**ADDENDUM NO 3  
TO  
CONTRACT DOCUMENTS  
FOR  
JORDAN VALLEY WATER TREATMENT PLANT RECLAIM WATER AND SOLIDS  
HANDLING IMPROVEMENTS**

**[DISTRICT PROJECT NO.: 4072]**

**August 31, 2020**

JORDAN VALLEY WATER TREATMENT PLANT  
RECLAIM WATER AND SOLIDS HANDLING IMPROVEMENTS  
TYPICAL DETAILS  
PIPING TYPICAL DETAILS 3

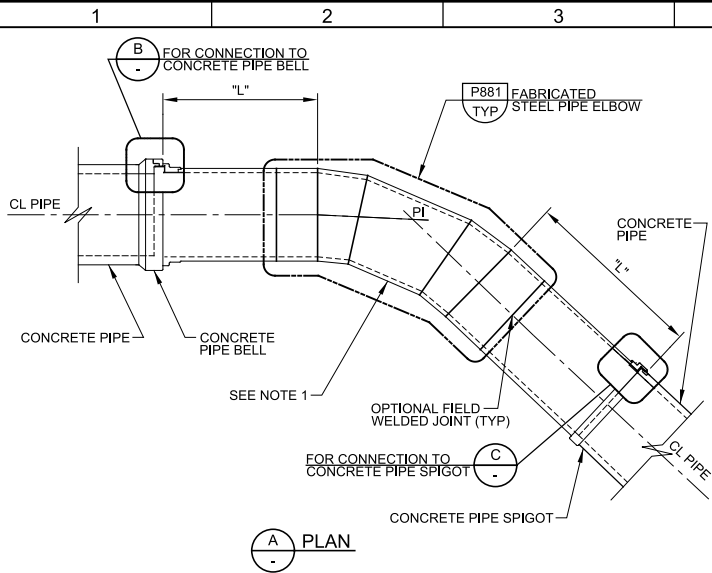
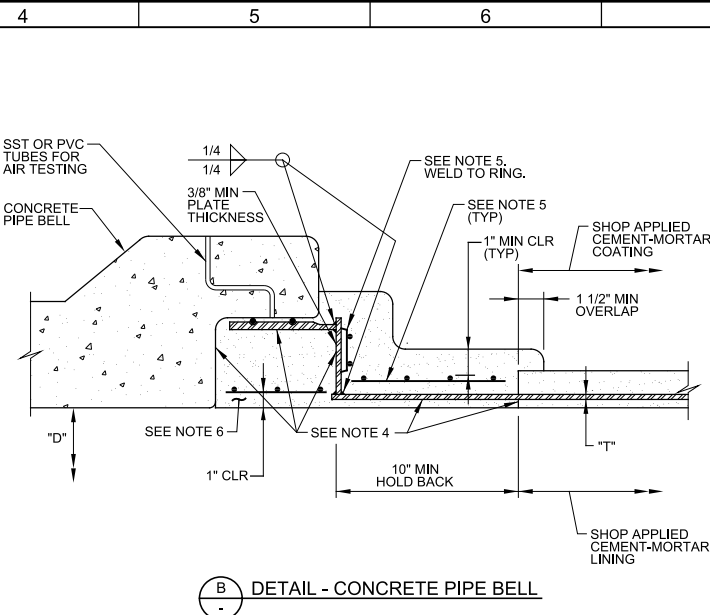
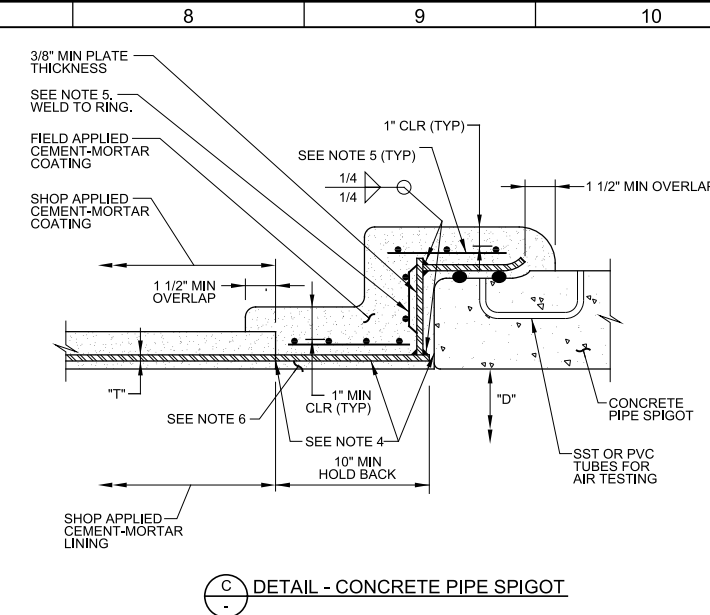
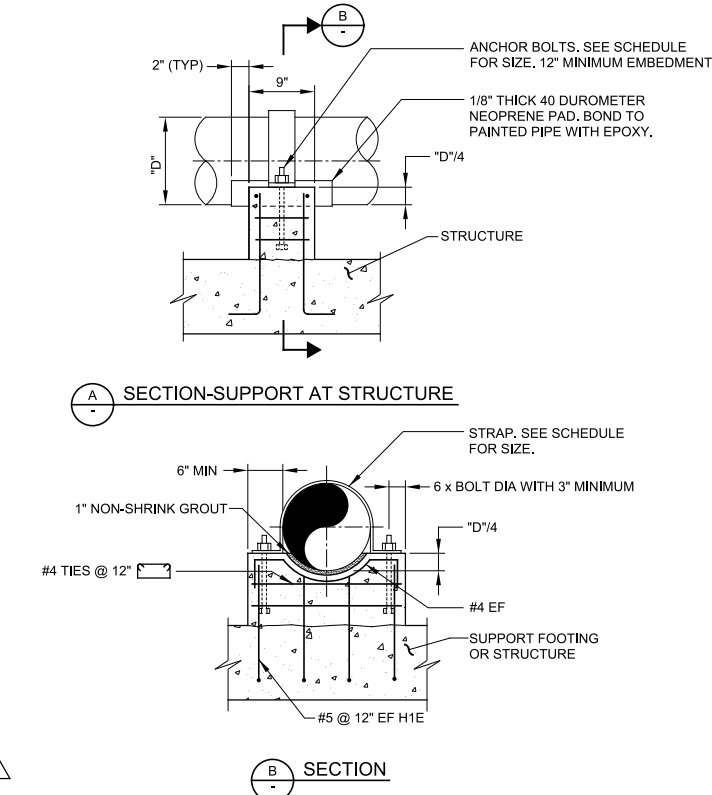
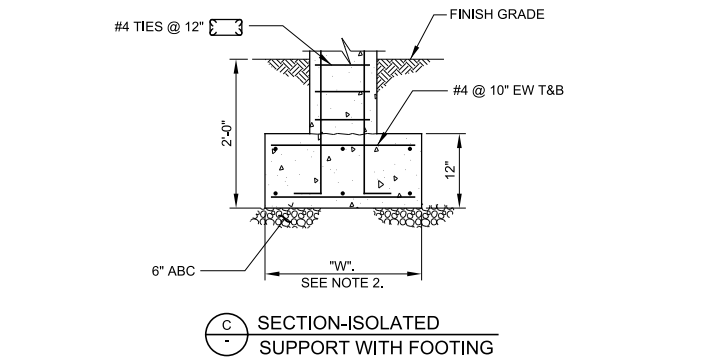
G. Drawing TP03 PIPING TYPICAL DETAILS 3

1. Replace drawing in its entirety with the attached drawing.
